Service Bulletin

Bulletin No.: 21-NA-102

Subject: Information on Replacing Hood Latch

Brand:	Model:	Model Year:		VIN:		Engine:	Transmission:
		from	to	from	to		
Chevrolet	Camaro	2016	2018	—	—	All	All

5807138

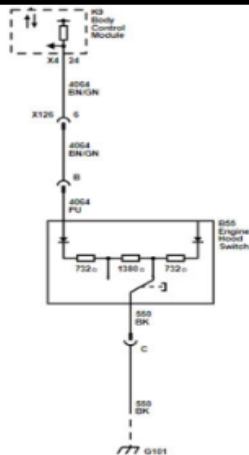
When replacing the hood latch, the service replacement P/N 84678990 will also require the use of connector P/N 19368220. This new service latch has a three-wire connector, while the original latch P/N 84053842 on Model Years 2016-2018 will only have a two-wire connector.

1. The new connector will come with three leads. The yellow wire needs to remain installed for water intrusion protection. The extra lead needs to be sealed using a DuraSeal splice sleeve and taped back into the harness. Refer to *Wire to Wire Repair* in Service Information (SI) for more information.
2. The schematic document ID: 4673035 in SI shows a purple wire on the latch - on the new connector this is a red wire. Connect the red wire on the connector to the BN/GN wire in the vehicle harness.
3. Connect the black wire on the connector to the black wire on the vehicle harness.
